New FC Endwall Trial Assembly

Overview

- Endwalls
- Comments/feedback on assembly
- QA/QC

Assembly

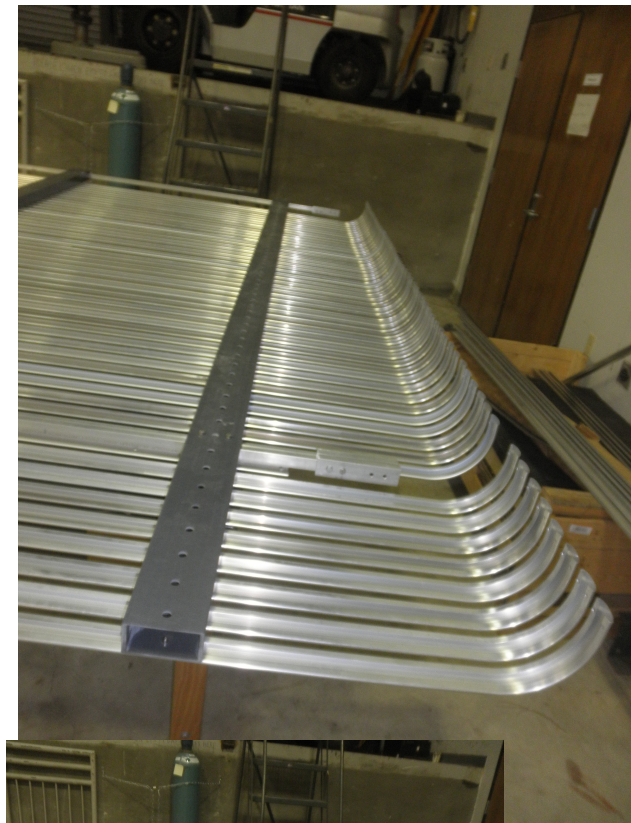
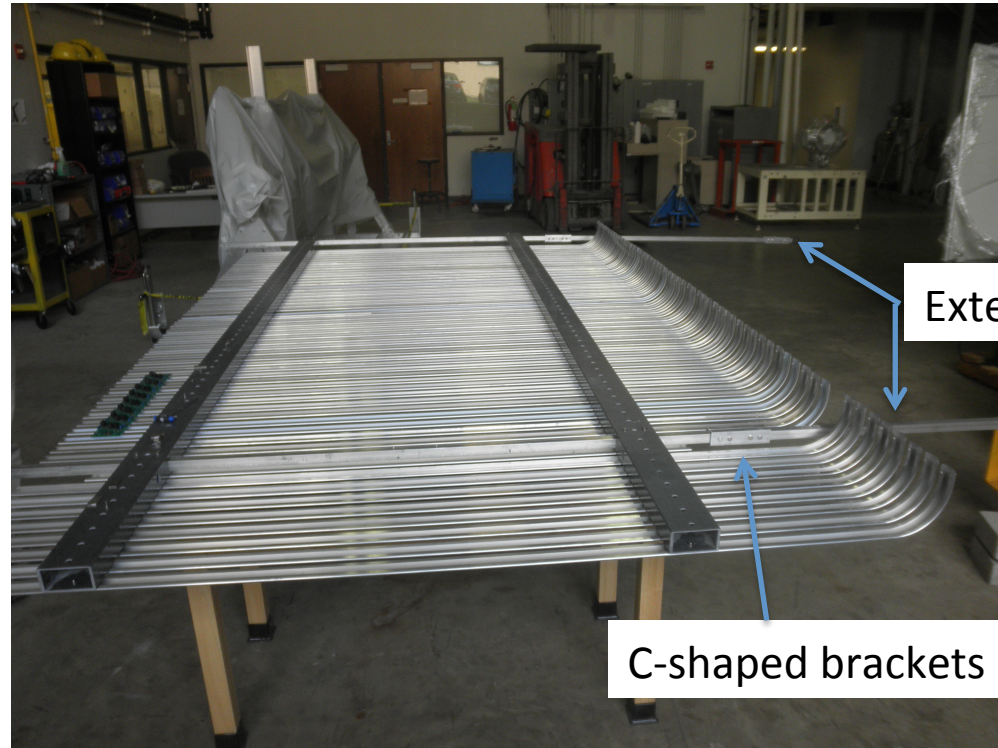
1. FRP box beam + Al rod frame
2. Slip nuts and Al profile (one at a time)
Alignment of profiles not yet fine tuned → manufacture/use dedicated tools

- Frame is straight forward to assemble, sturdy and easy to handle/turn with 2 people
- Some profiles catch edge of slip nut and don't install easily
→ refine installation method and reduce slip nut size

Assembly

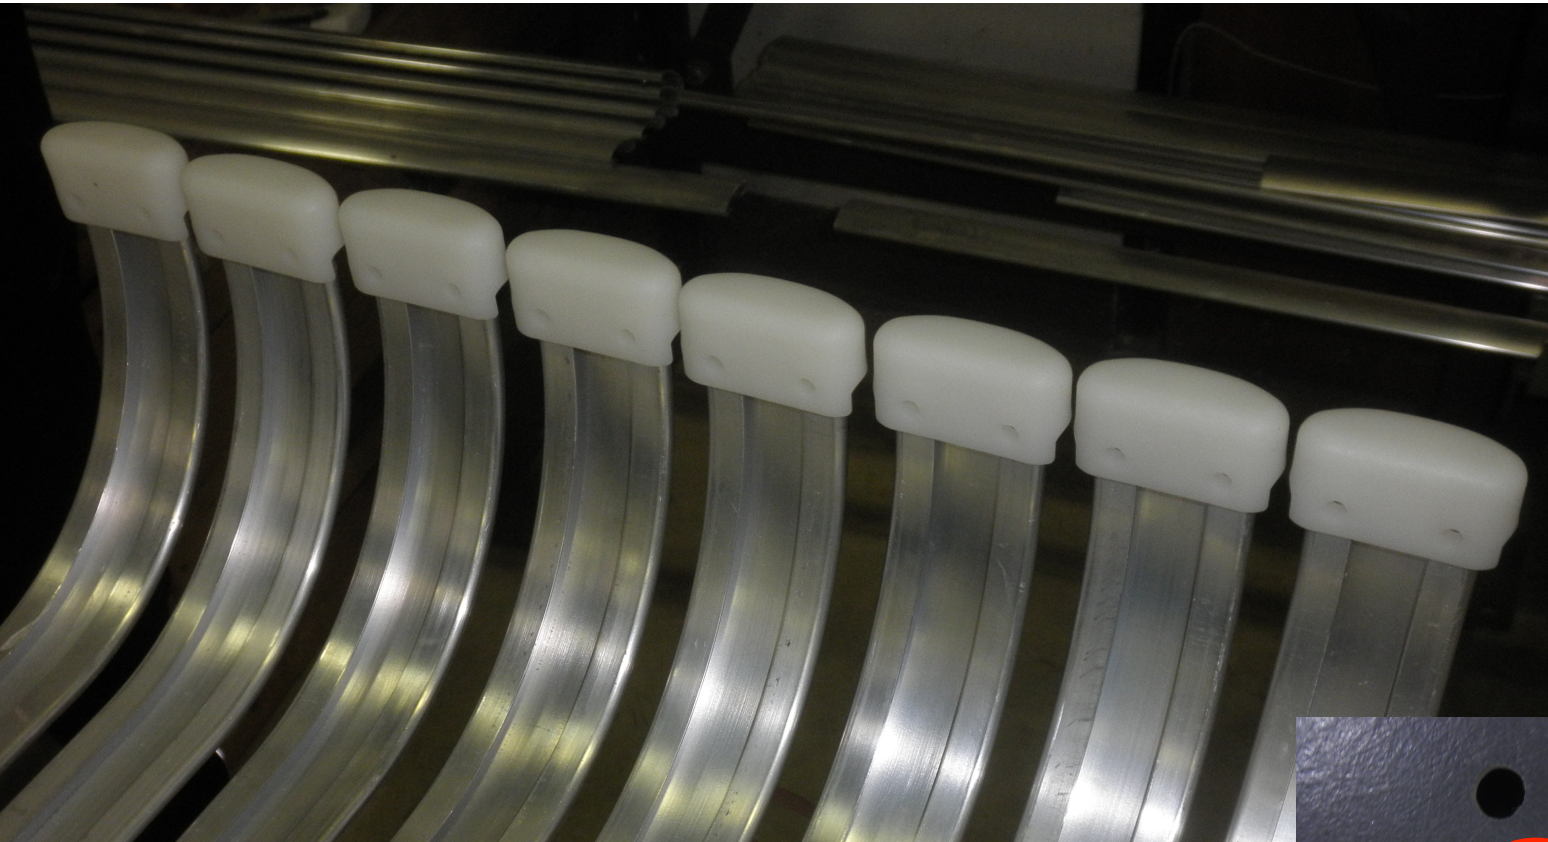
- Fully assembled panel requires 3 - 4 people to handle/turn

Pre-assembly:

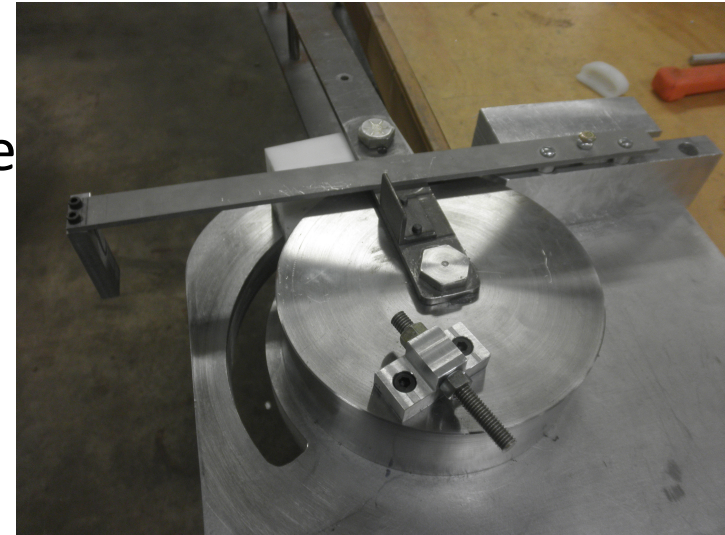
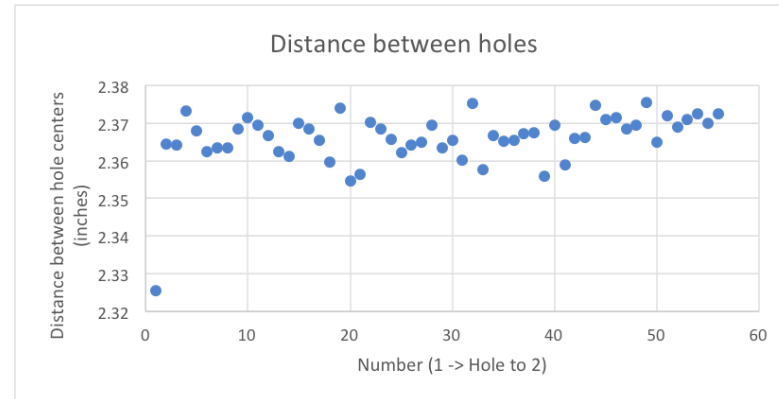
- Box beam hole measurements
- Bend profile length and bend position

→ Presently working on manufacturing dedicated QC tools
